CASE NO: CPC-ZC21-04

**SUBJECT: SUPPLEMENTAL STAFF REPORT FOR COMPREHENSIVE PLAN CHANGE /
ZONE CHANGE NO. 21-04; 2900 BLOCK OF KUEBLER BLVD SE (AMANDA
APPLICATION NO. 21-115803-ZO; 21-115805-ZO)**

SUBJECT: RESPONSE TO CITY OF SALEM COMMENTS: BOONE ROAD COMMERCIAL TPR ANALYSIS (ROUND 2)

- A. Concept Design Layout & Cost Estimate for 27th Avenue between Kuebler Blvd and Site Access
- B. Revised Figure 3 (Trip Generation & Distribution)

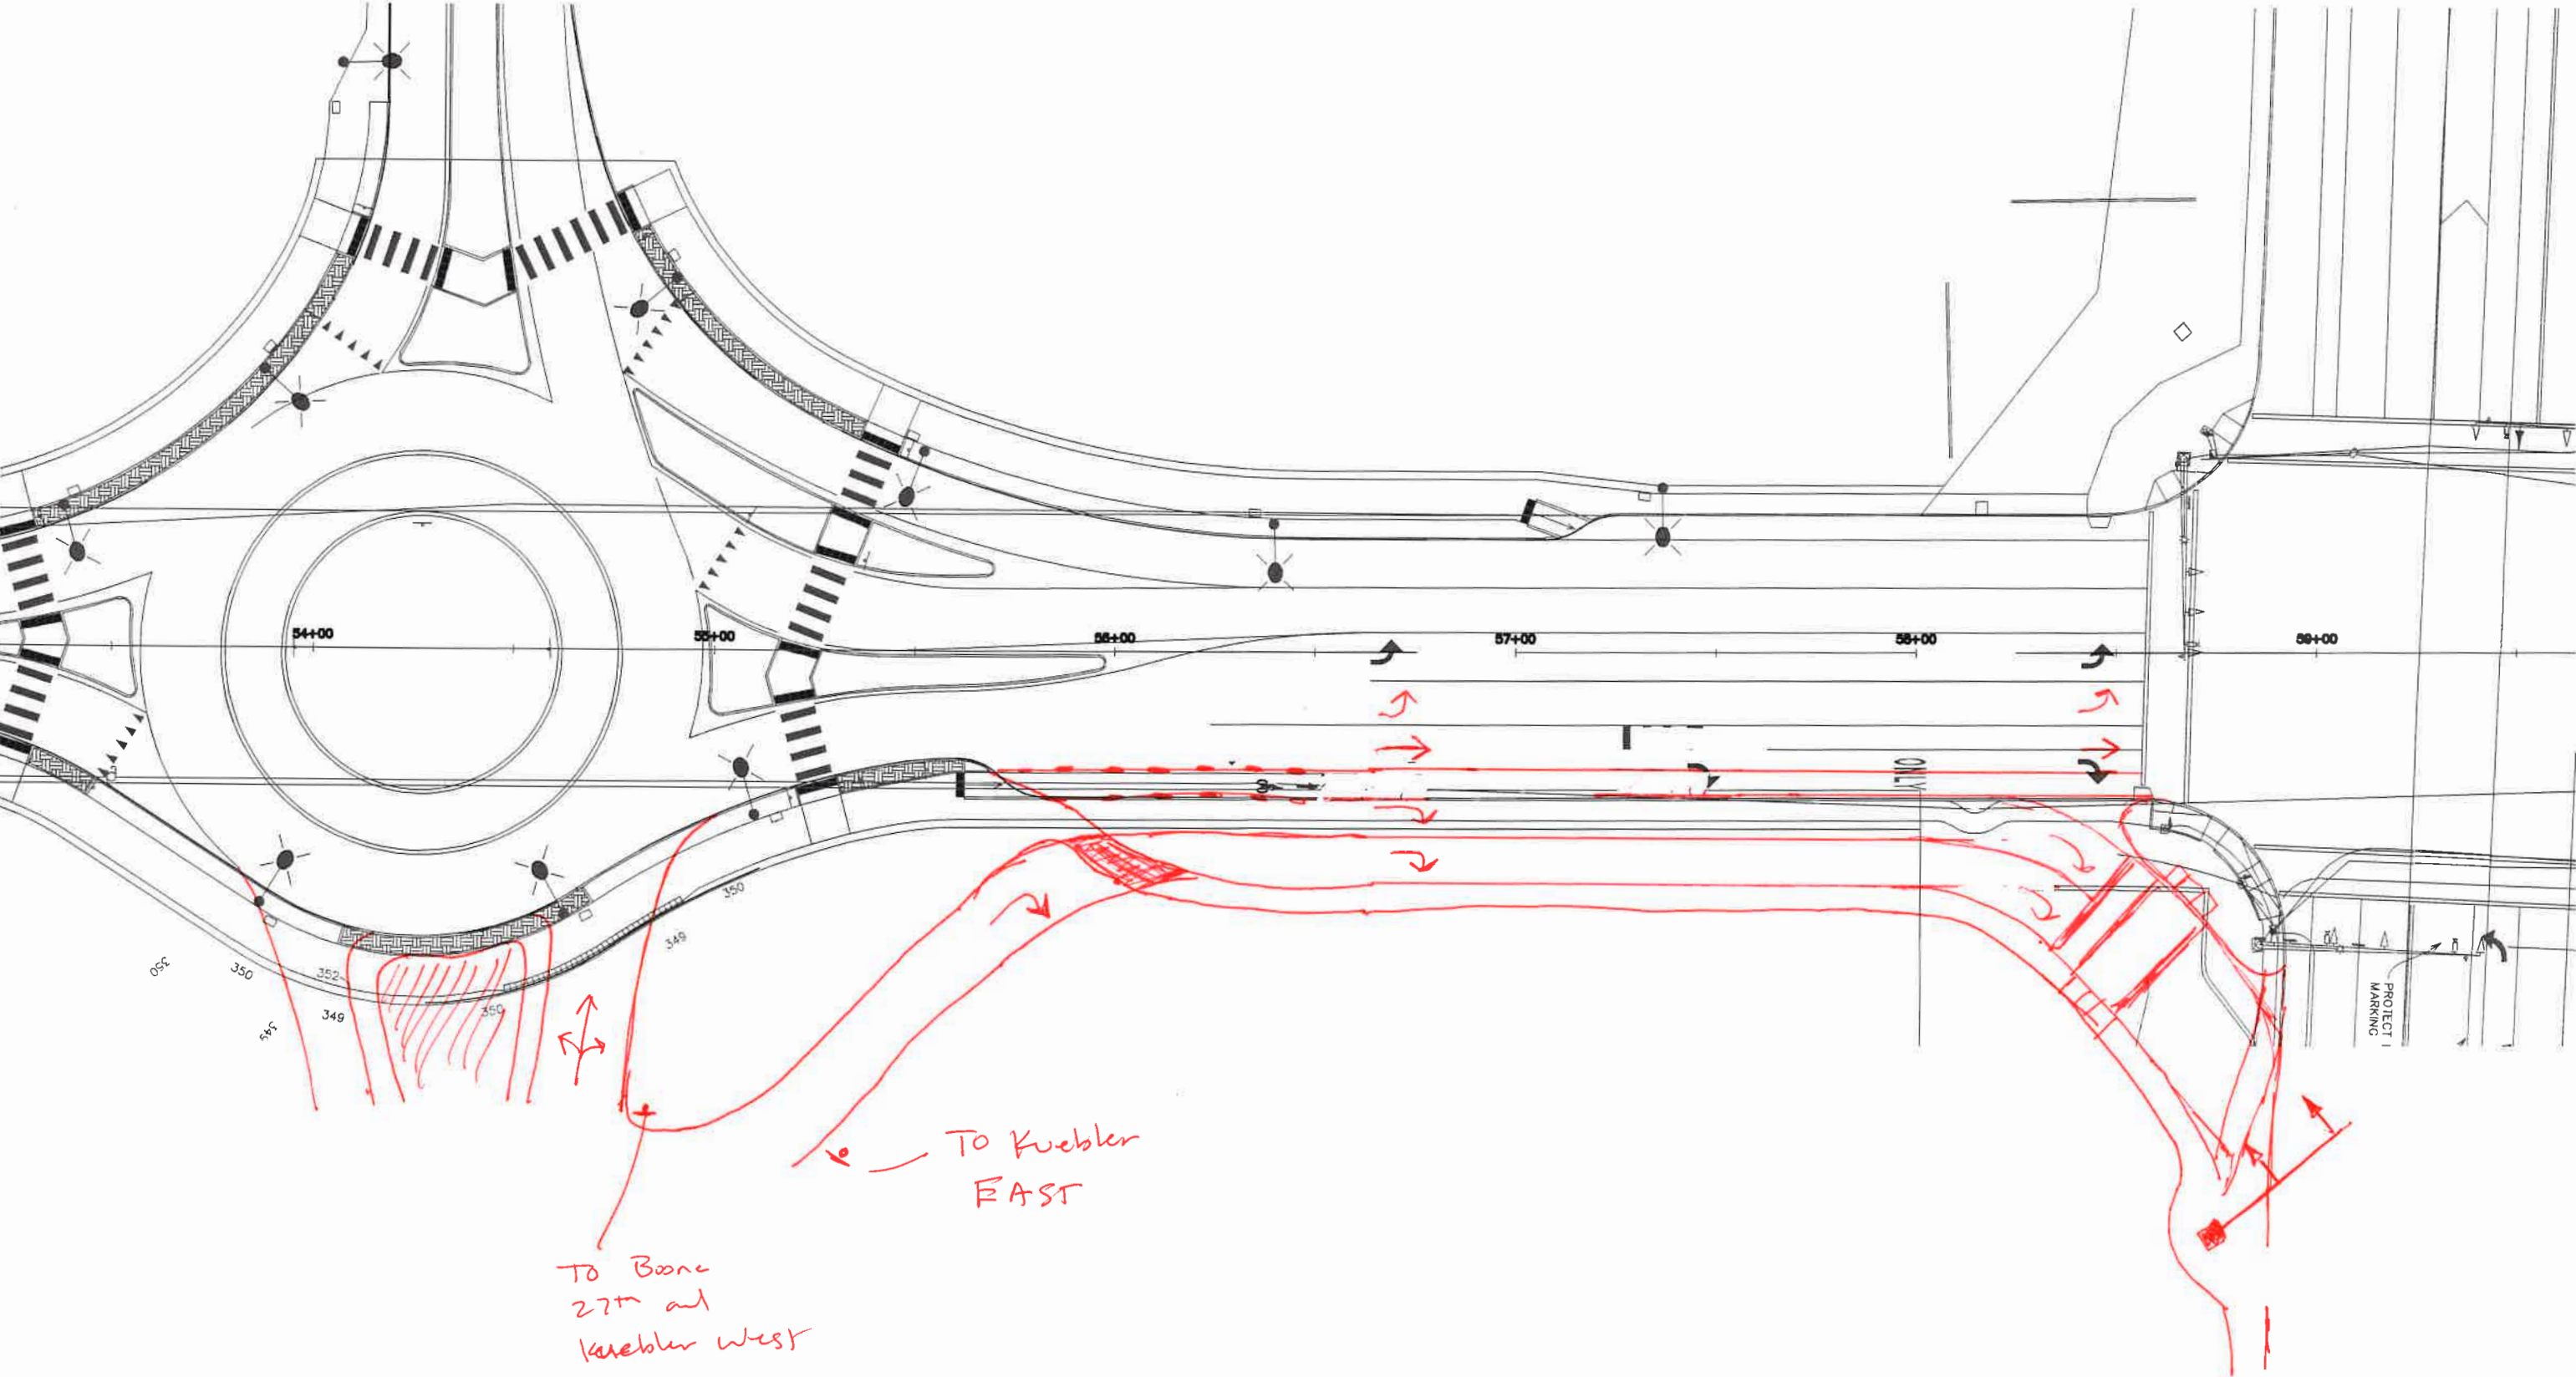
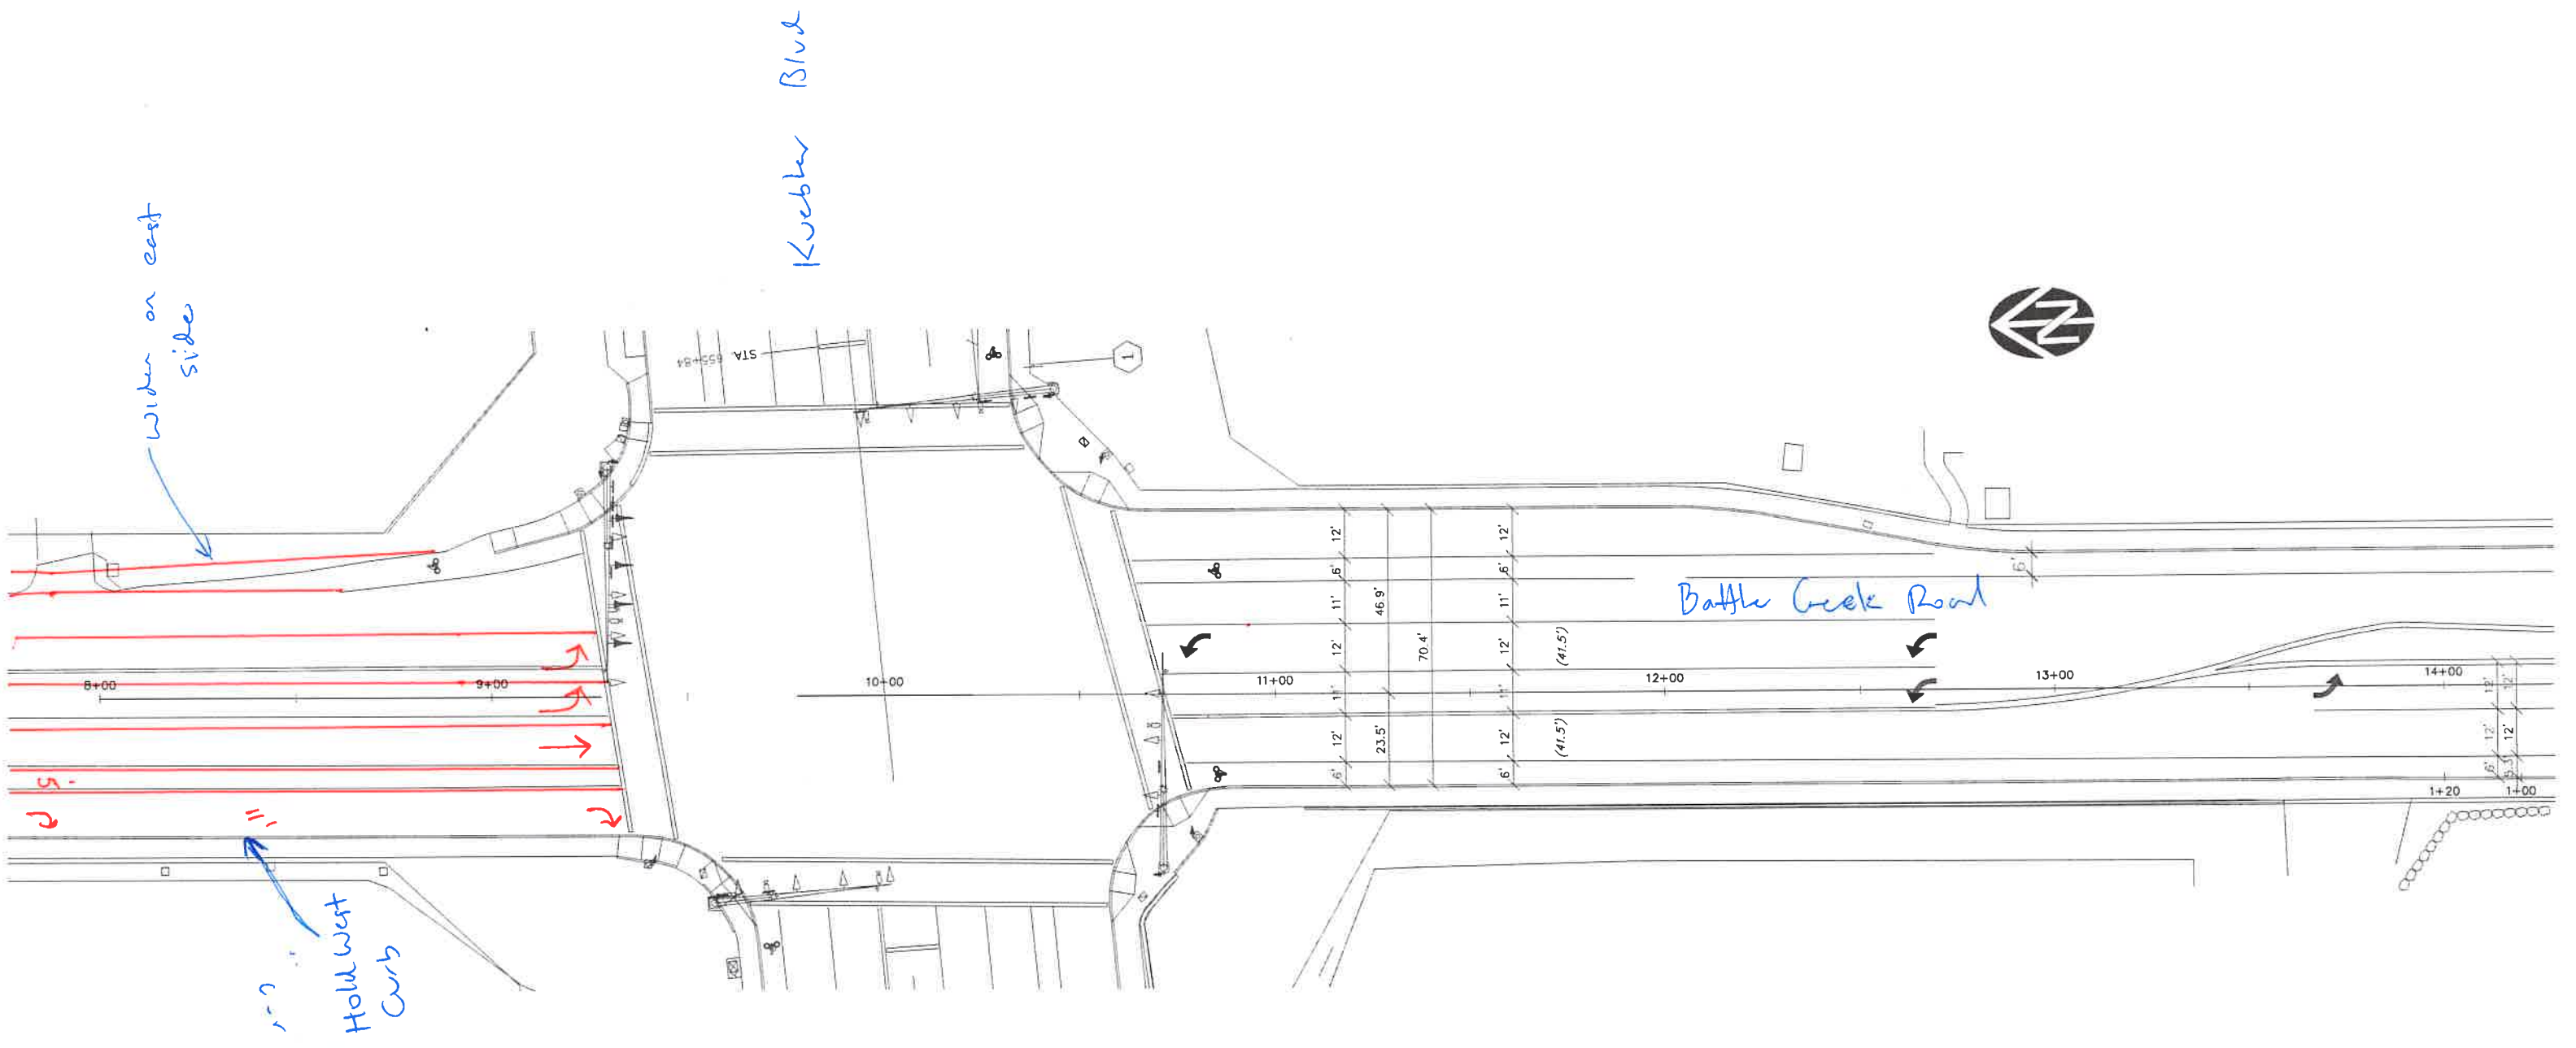
- Staff raised concerns that the proposed mitigation is for double left turn lanes and double right turn lanes for northbound 27th at Kuebler. It is unclear how the lanes would function, specifically how cars would safely maneuver out of the round-about and the site driveway.
- *DKS provided an attachment to their letter with a conceptual design layout and cost estimation showing the segment of 27th Street between Kuebler Blvd and the site access round-about for the proposed mitigation.*

Staff Response: Upon review, there are concerns with lane widths for the right turn lanes which seem to be narrower than standard. Based on the applicant's analysis, the 300-foot queuing of left turning vehicles will place the last vehicle in the pedestrian crosswalk marking, meaning that any vehicles trying to get to the through or right-turn lanes will be within the round-about. This may block other traffic using the round-about, causing it to fail during peak times.

2. Proposed mitigation is for double left turn lanes and double right turn lanes for NB 27th at Kuebler. Need to show how that would be designed. It is unclear how the lanes would function coming off round-about and the site driveway.

DKS: Refer to Attachment A for a conceptual design layout showing the segment of 27th Street between Kuebler Blvd and the site access roundabout for the proposed mitigation. An updated cost estimate for the project is also provided in the attachment.

DKS: See the concept design in Attachment A. Two northbound lanes are provided as vehicles exit the roundabout. Guide signage on-site directing vehicles to select the desired lane prior to entering the roundabout will limit weaving within this segment.
